Amendments to the Drawings:

Remarks

Fig. 10

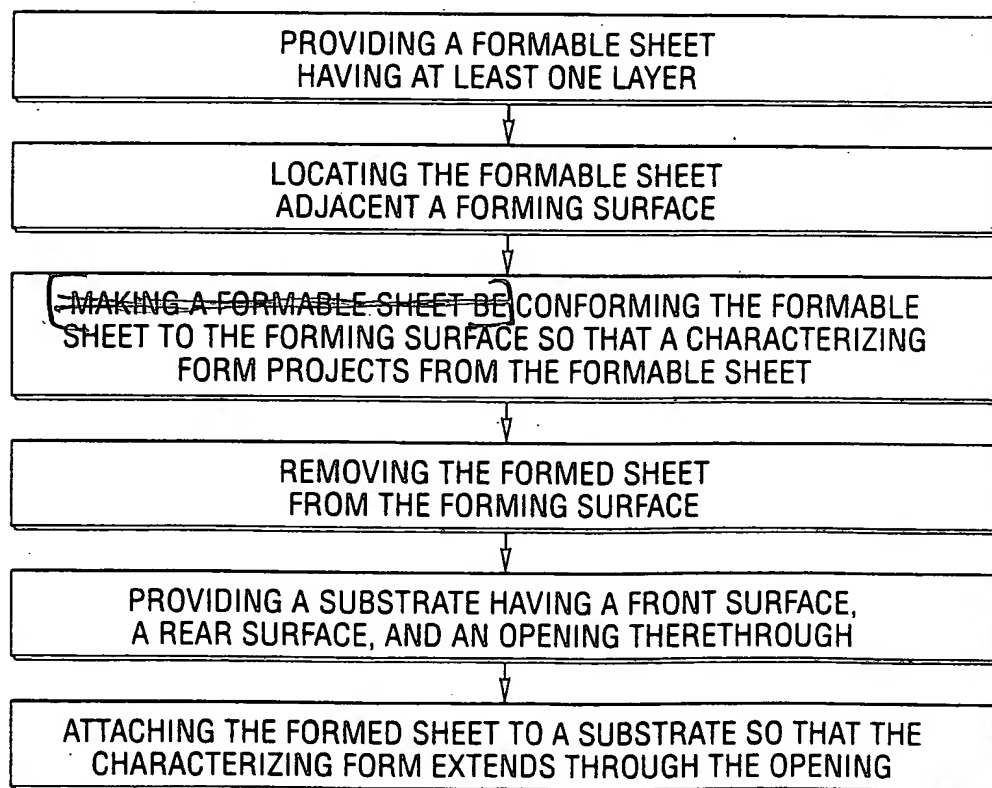
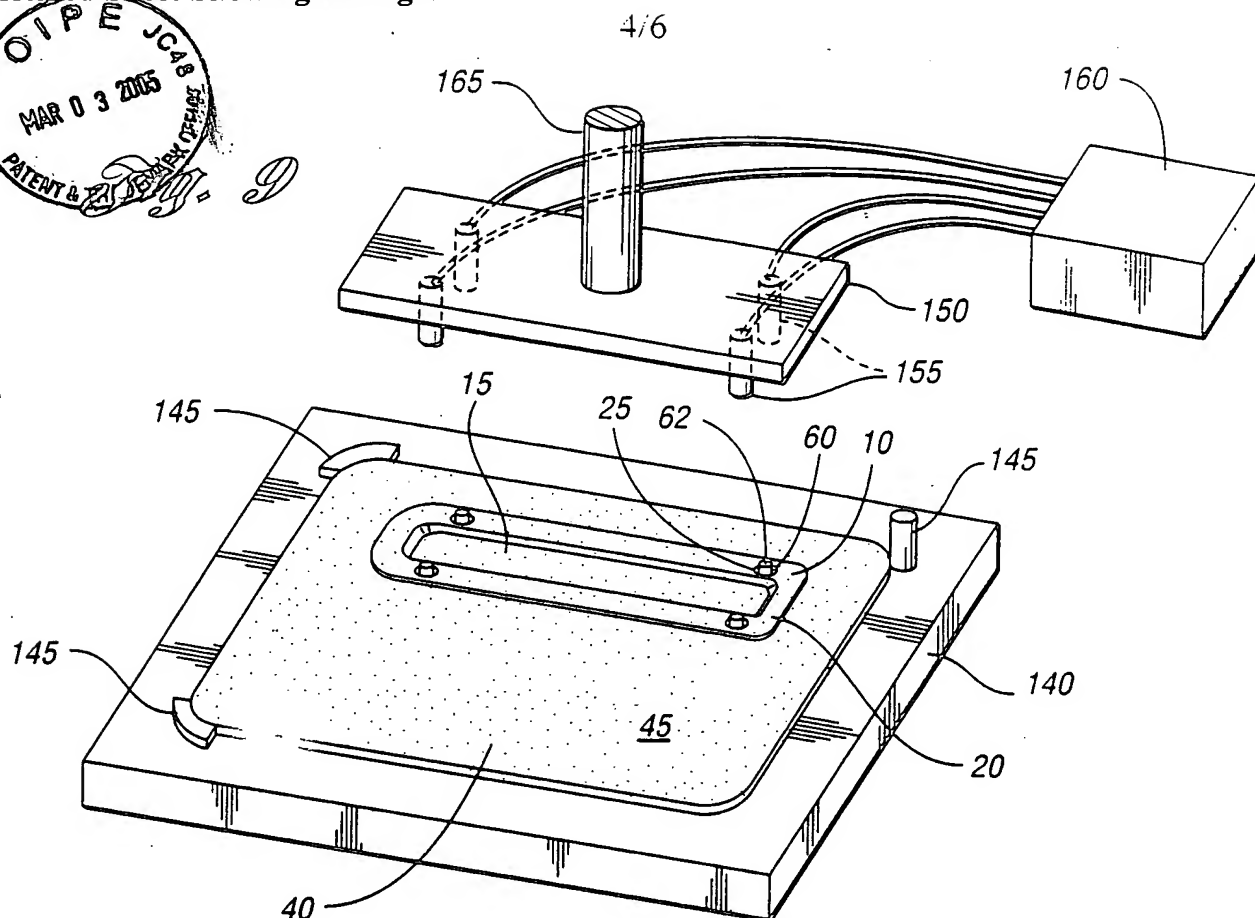
The attached sheet of drawings includes changes to Fig. 10. This sheet, which includes Figs. 9 & 10, replaces the original sheet including Figs. 9 & 10.

Applicant has taken this opportunity to correct an error in the drawings as filed by deleting superfluous verbiage from Figures 10 and 17. Approval of the proposed change (identified in red) is requested.
